Micro Bird Inc

RECALL CAMPAIGN

TITLE: Positive battery feeder stud and battery box

installation bolts

Step 1:

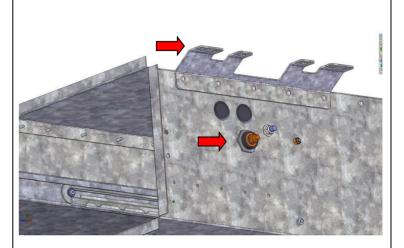
Visually inspect as follow:

- See if rivets and/or bolts are missing on the bracket designed to install the battery compartment. Your bracket may be different then the picture.
 - Let If the rivets be missing <u>and/or</u> loose, please order your replacement kit. Note that rivets are not designed to support the weight of the battery box without bolts. (See Step 9 for bolts installation).
- See if there is any corrosion in and out the battery box by the positive feeder stud.

Left components are corroded, please order your replacement kit.

Step 9:

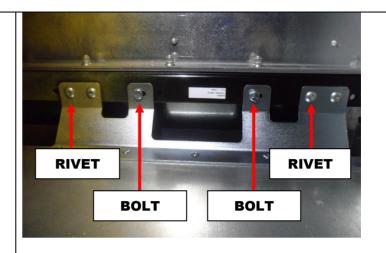
If bolts are missing, now is the time to install. Six bolts will be provided (which is more than what you really need).

If rivets are missing, please install bolts in these holes.

Please note that you may have another model of bracket.

Rivet:

has a convex and rounded top.

Bolt:

has a flat and six-side top.
